## PUBLIC INTEREST REVIEW FOR GROUNDWATER APPLICATIONS

TO:		Wate	r Rights Se	ction				Date	Jai	nuary	12, 201	1		
FROM:	:	Grou	ndwater Se	ction	Marc No									
SUBJE	CT:	Appli	ication G	17437			ewer's Nam persedes		view of			Date of Rev	view(s)	
OAR 69 welfare, to determ	<b>90-310-1</b> 3 safety an mine whe	<b>30 (1)</b> <i>ind heal</i> ether th	<i>th as descri</i> e presumpti	nent shall p bed in ORS on is establ	resume that 537.525. D ished. OAR	t a propos epartment . 690-310-	red groun t staff rev 140 allov	iew vs tł	ater use will groundwate ne proposed agency poli	er applica use be m	ne pres utions u	ervation of the or condition of the or conditi	of the put R 690-31 itioned to	10-140 meet

A. <u>GEN</u>	NERAL	INFO	<u>PRMATIO</u>	<u>N</u> : A	pplicant's N	Vame:	Jennifer	& I	Eric Miller		_ (	County:	Wasco	
A1.									Columbia					
A2.	Propose	d use_		gation – 5.4	45 acres	Seas	sonality:		nd Map: Du	rough (	Octobe	r 31		
A3.	Well an	d aquif	er data (atta Applicant's	,		Prop		mar	Location			tion, mete		nds a a
Well	Logid		Well #	Propos	ed Aquifer*	Rate	(cfs)		(T/R-S QQ-	-Q)	2250	' N, 1200'	E fr NW	cor S 36
2	WASC 3		1 2		CRBG CRBG	0.0			02S/13E-18 SI 02S/13E-18 SI		1275' N, 500' W

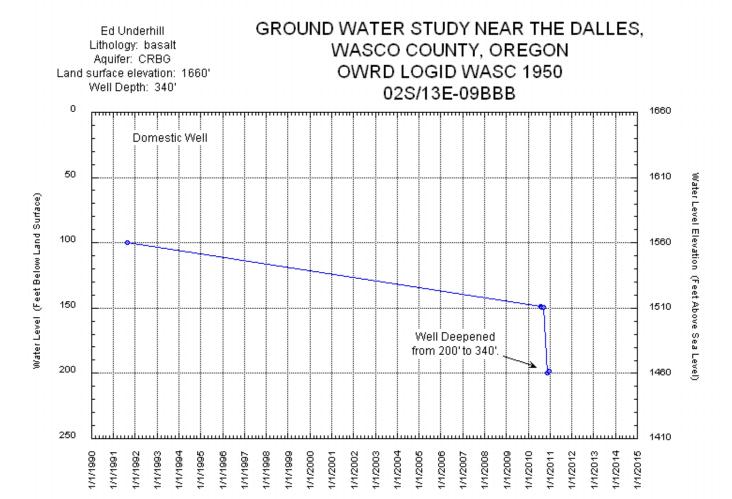
e.	■ <b>Well reconstruction</b> is necessary to accomplish one or more of the above conditions. The problems that are likely to occur with this use and without reconstructing are cited below. Without reconstruction, I recommend withholding issuance of the permit until evidence of well reconstruction is filed with the Department and approved by the Groundwater Section.
	<b>Describe injury</b> —as related to water availability— that is likely to occur without well reconstruction (interference w/ senior water rights, not within the capacity of the resource, etc):
Jan on 6 the leve	bundwater availability remarks: A water level was measured at well #1 (WASC 3975) on January 10, 2011. The muary water level was lower than the water level reported on the well log by about 8 feet. The water level was 101 6/13/1979. The amount of decline is probably greater than 8 feet when corrected for the difference in seasons of measurements. A well, WASC 1950, located about two miles northeast was recently deepened because the water el had declined about 49 feet in from 8/16/1991 to 8/23/2010. When deepened, the well penetrated a deeper aquifer ha water level about 50 feet lower. See Graph. WASC 3975 develops water from a different aquifer that WASC 10.
